SAN ANTONIO WATER SYSTEM
 I.H. 10 Ground Storage Tank
 Rehabilitation and Painting Project
 SAWS Job No. 13-0118
 Solicitation No. B-16-014-GC

ADDENDUM NO. 2

August 31, 2016

PROPOSED SITE PLAN

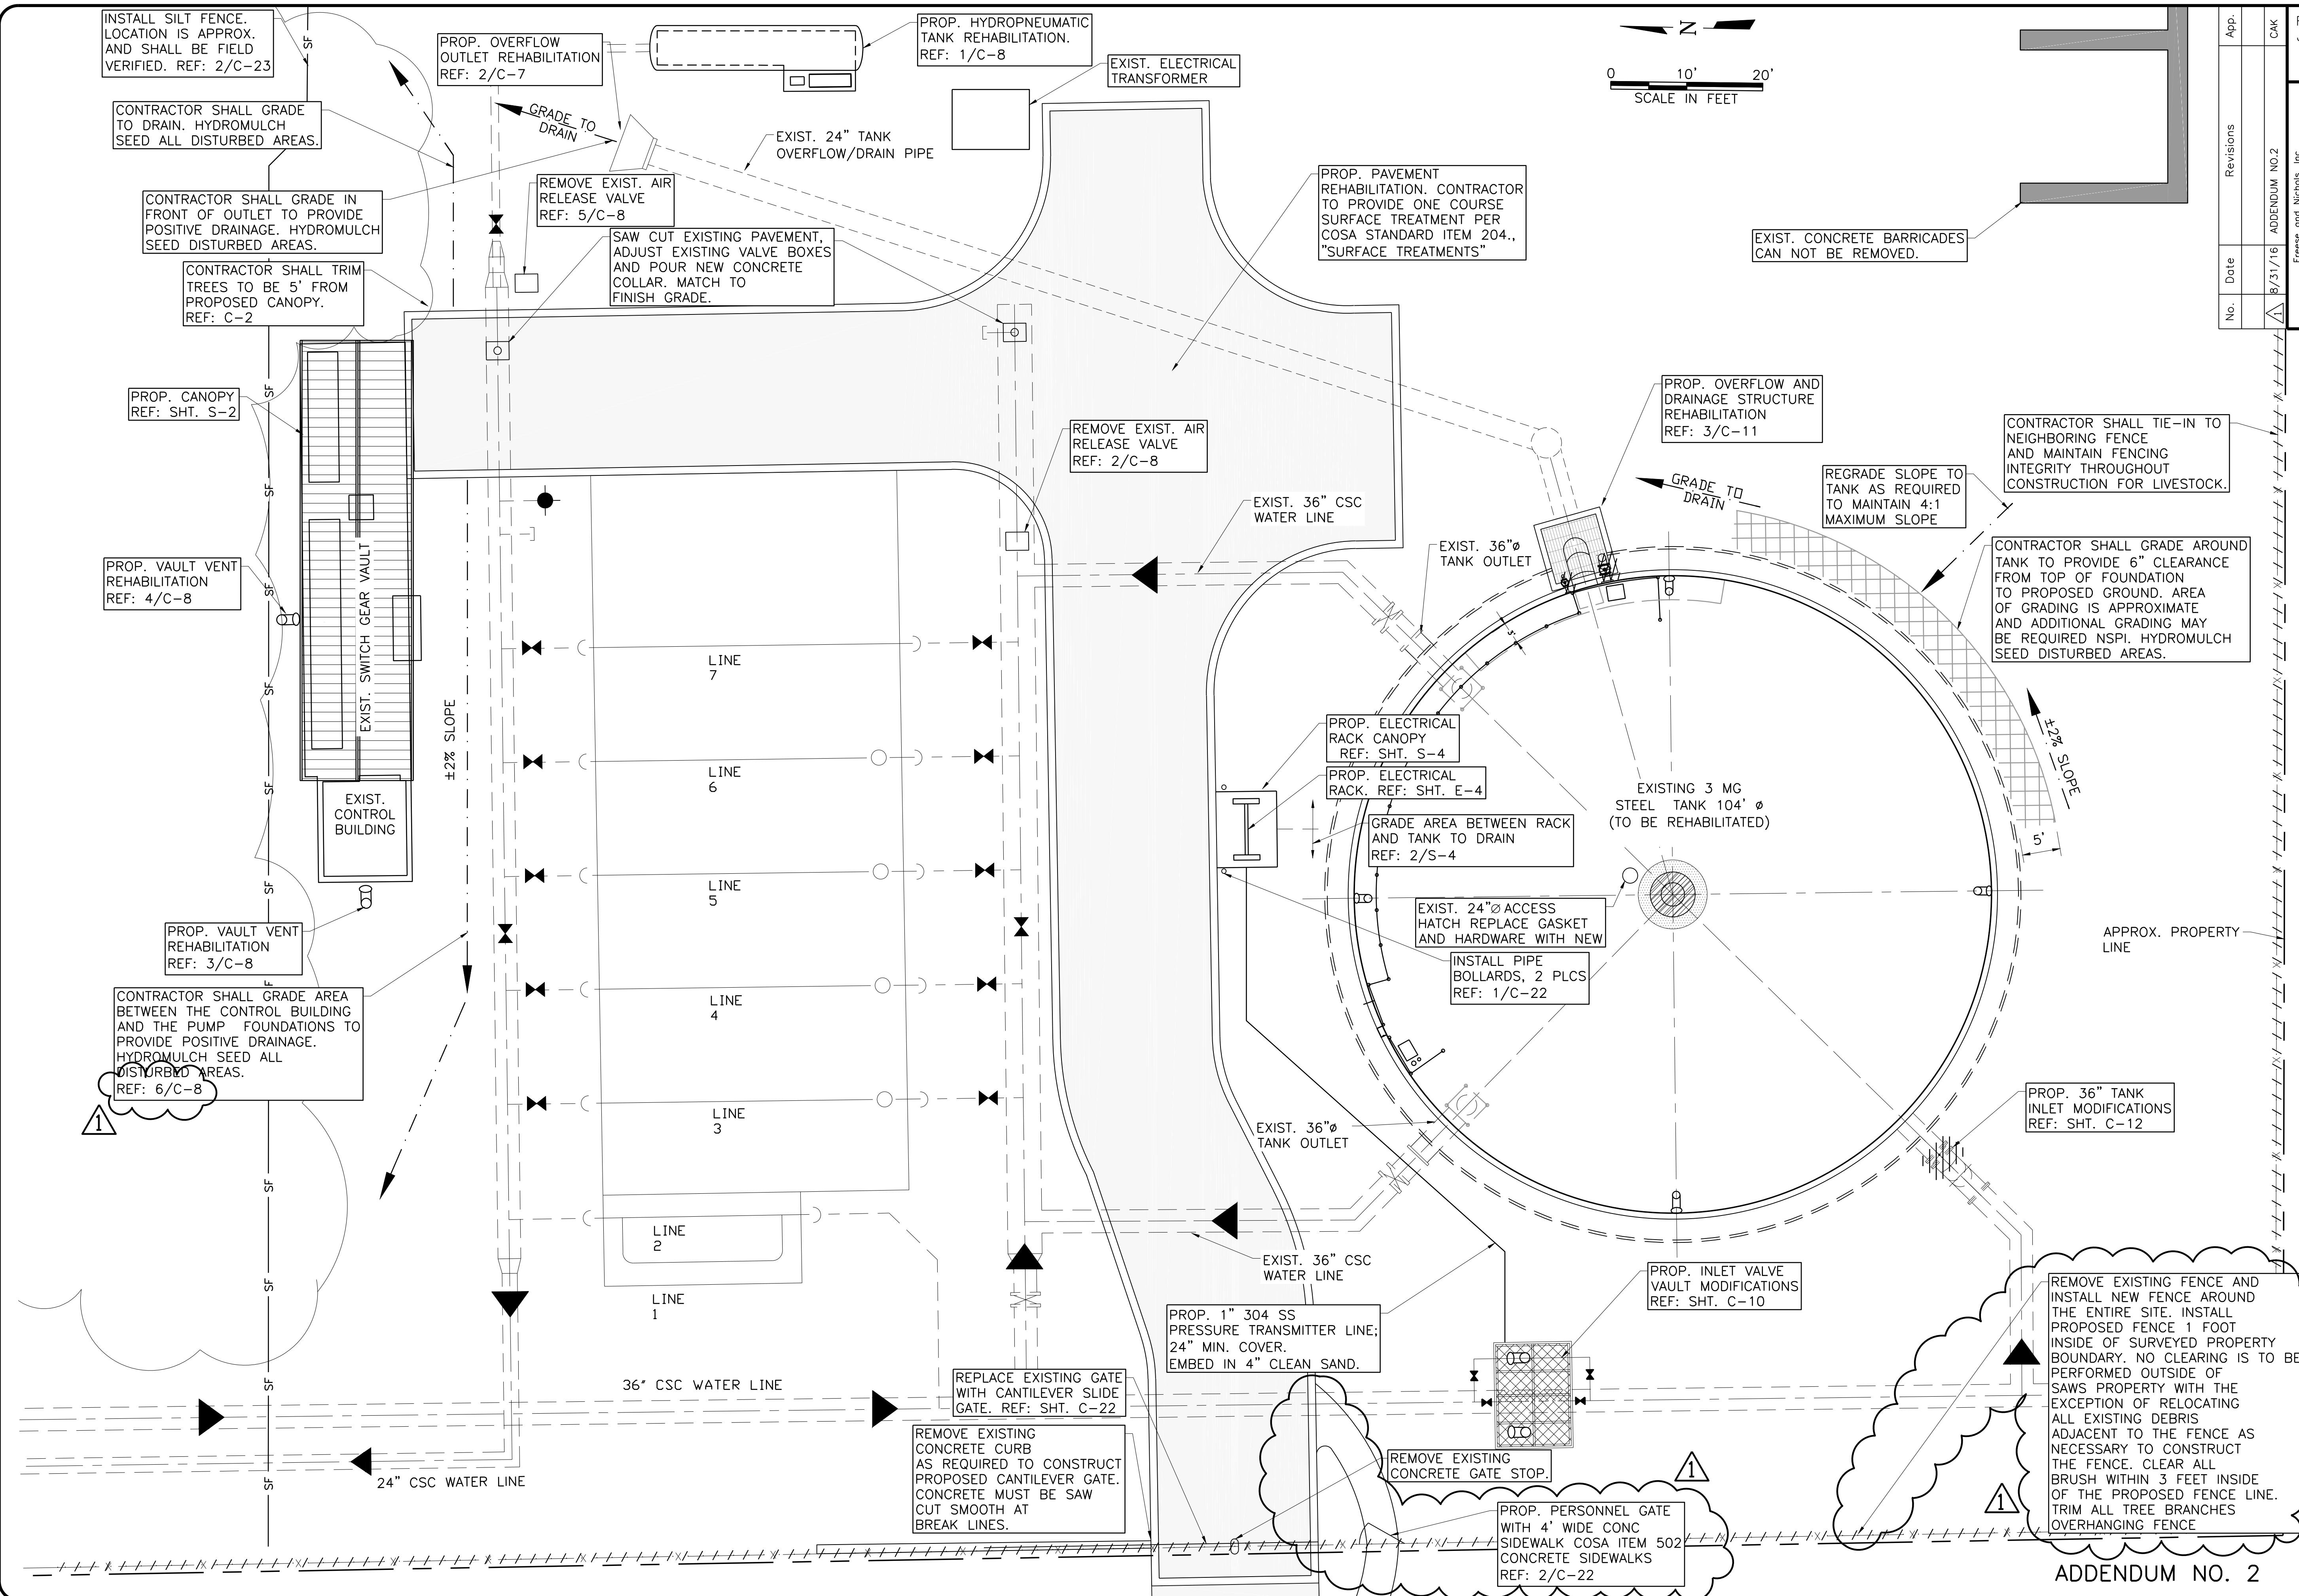
REMOVE and REPLACE sheet C-3 with the attached sheet.

SAWS JOB NO. 13-0118
I.H. TO GROUND STORAGE TANK
REHABILITATION AND PAINTING PROJECT
MISCELLANEOUS PAINTING AND ELECTRICAL

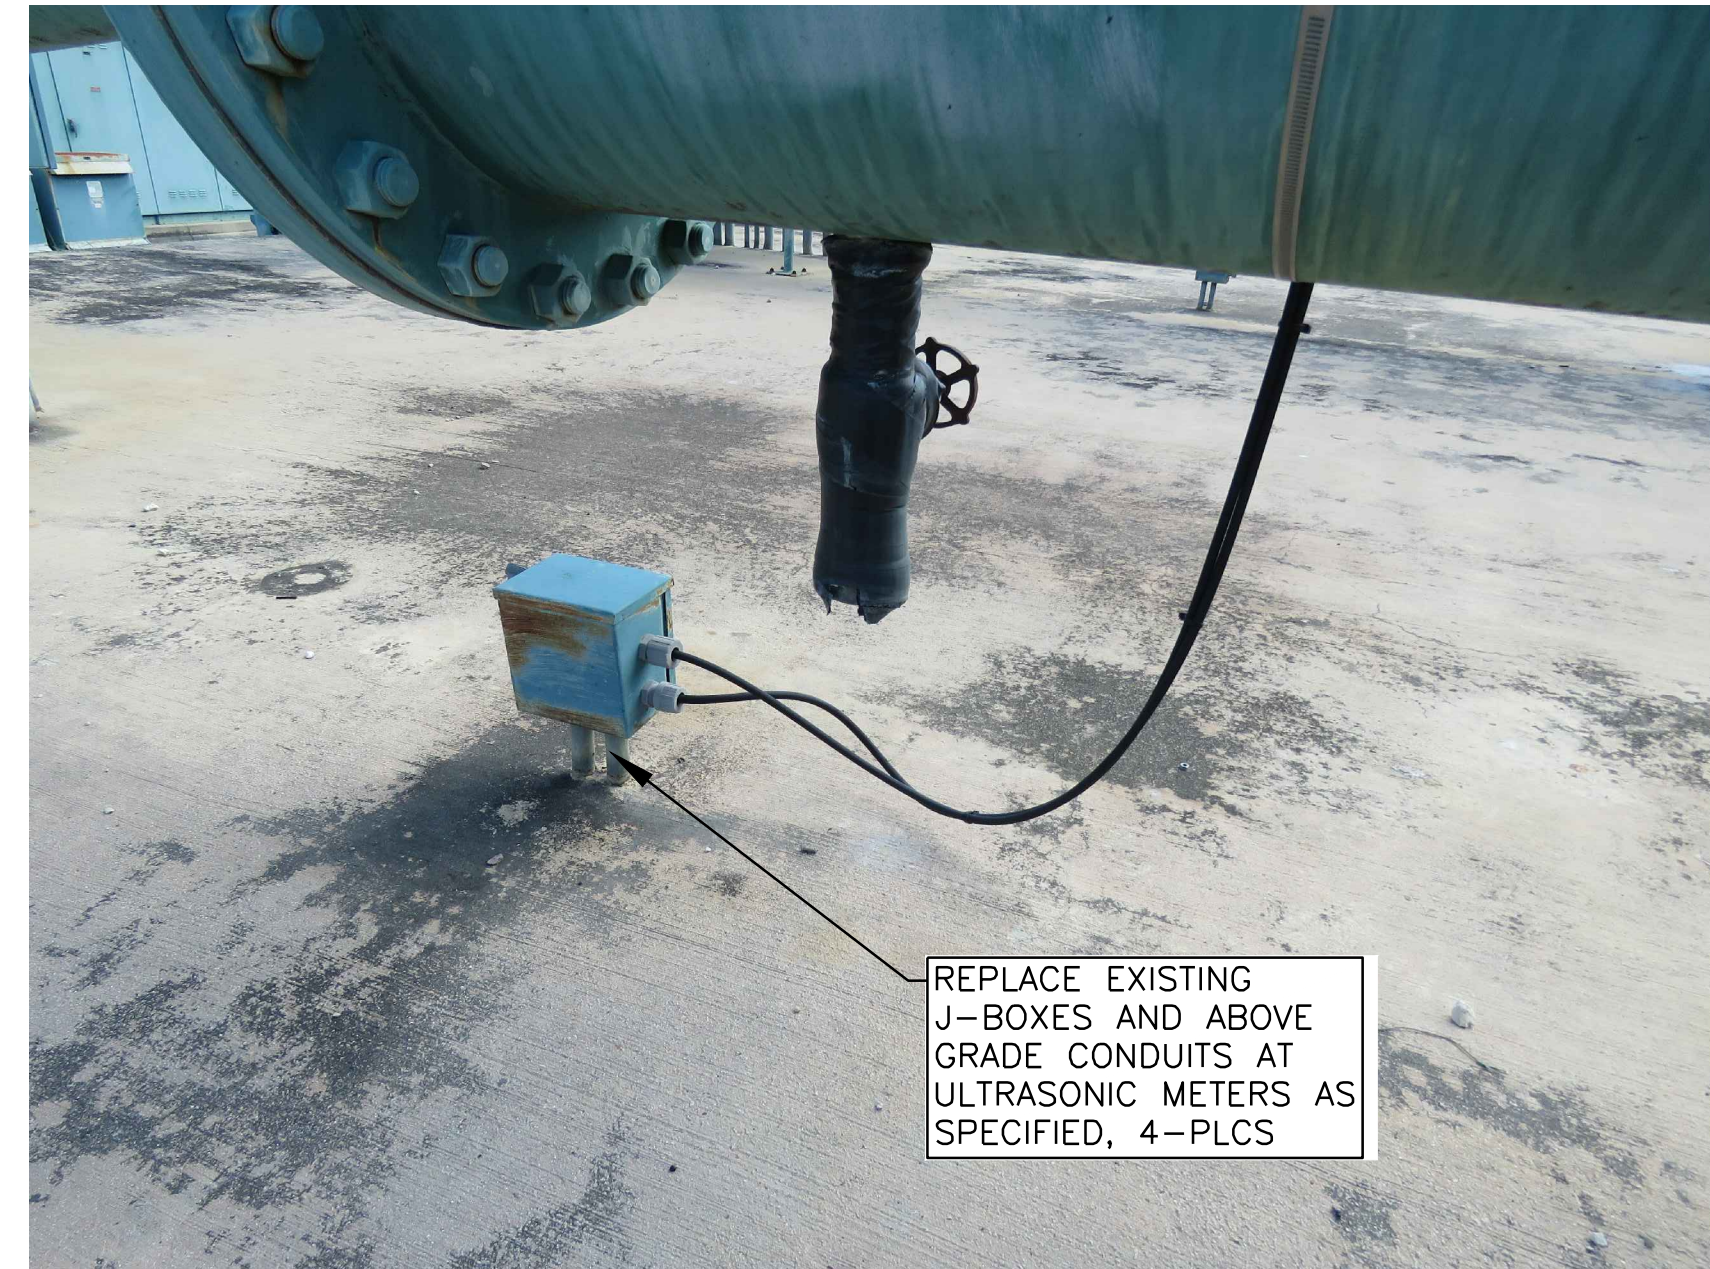
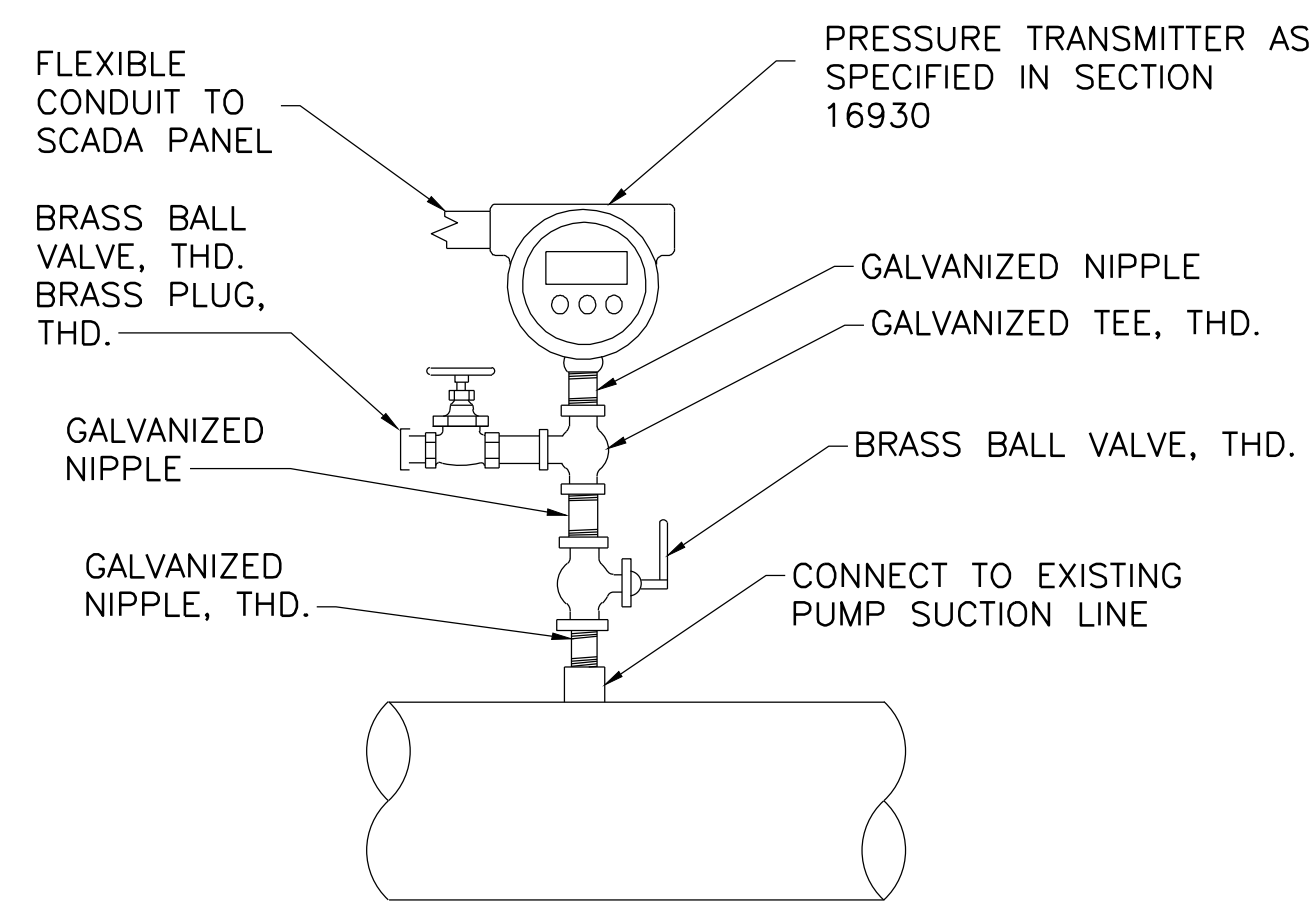
REPLACE EXISTING J-BOXES, PRESSURE SWITCHES AND ABOVE GRADE CONDUITS AT PUMP SUCTION, AS SPECIFIED, 4-PLCS. SEE DETAIL 3

REPLACE EXISTING J-BOXES AND ABOVE GRADE CONDUITS AT ULTRASONIC METERS AS SPECIFIED, 4-PLCS

- CONTRACTOR MUST PREPARE AND COAT ALL STEEL EXTERIOR ELECTRICAL PANELS, SWITCH GEAR, MCC'S, MOTORS, INSTRUMENTATION PANELS, ETC. AT THE PUMP STATION AND AT THE ELECTRICAL/SWITCHGEAR. ALL PANELS MAY NOT BE INDICATED ABOVE. CONTRACTOR MUST FIELD VERIFY WITH INSPECTOR. STAINLESS STEEL PANELS DO NOT NEED TO BE REHABBED.

- CONTRACTOR WILL BE RESPONSIBLE FOR PROTECTING ELECTRICAL EQUIPMENT AND AVOID ABRASIVES OR COATINGS FROM ENTERING PANELS, MOTORS, ETC. ALL DAMAGE WILL BE THE RESPONSIBILITY OF THE CONTRACTOR.

- CONTRACTOR MUST PROTECT ALL EQUIPMENT MANUFACTURER'S NAMEPLATES.
- REPLACE EXISTING WARNING LABELS AND EQUIPMENT IDENTIFICATION LABELS AS SPECIFIED.
- REPLACE ALL CORRODED ELECTRICAL FITTINGS AT BOXES. FITTINGS IN GOOD CONDITION DO NOT NEED TO BE REPLACED. FIELD VERIFY WITH INSPECTOR.

- REPLACE INSULATED WIRES AND CONNECTION IF EXISTING INSULATION AND CONNECTIONS ARE FRAYED OR DAMAGED.
- PREPARE AND PROVIDE COLD GALVANIZING TO CORRODED GALVANIZED STEEL ELECTRICAL RACKS AND SUPPORTS.

- REPLACE ALL "DANGER, HIGH VOLTAGE" SIGNS READING "DANGER, HIGH VOLTAGE, KEEP OUT". COLOR SCHEME SHALL MATCH EXISTING.
- PUMPS SHALL BE TAKEN OUT OF SERVICE AND LOCKED OUT BY SAWS ELECTRICIAN WHEN ELECTRICAL EQUIPMENT INCLUDING MOTORS ARE PAINTED.

- CONTRACTOR MUST PROTECT ALL INDICATOR LIGHTS AND SWITCHES ON CONTROL PANELS.
- CONTRACTOR SHALL NOT PAINT FLOW METER ON ELECTRICAL RACK.
- PANEL IDENTIFICATION LABELS SHALL BE REPLACED WITH LABELS CONSTRUCTED OF THE SAME MATERIAL.

- J-BOXES SHALL BE NEMA 4X 316 STAINLESS STEEL.
- NEW PRESSURE SWITCHES AND CONDUIT SHALL MATCH EXISTING. CONTRACTOR TO COORDINATE WITH SAWS FOR PRESSURE SWITCH SETTINGS.
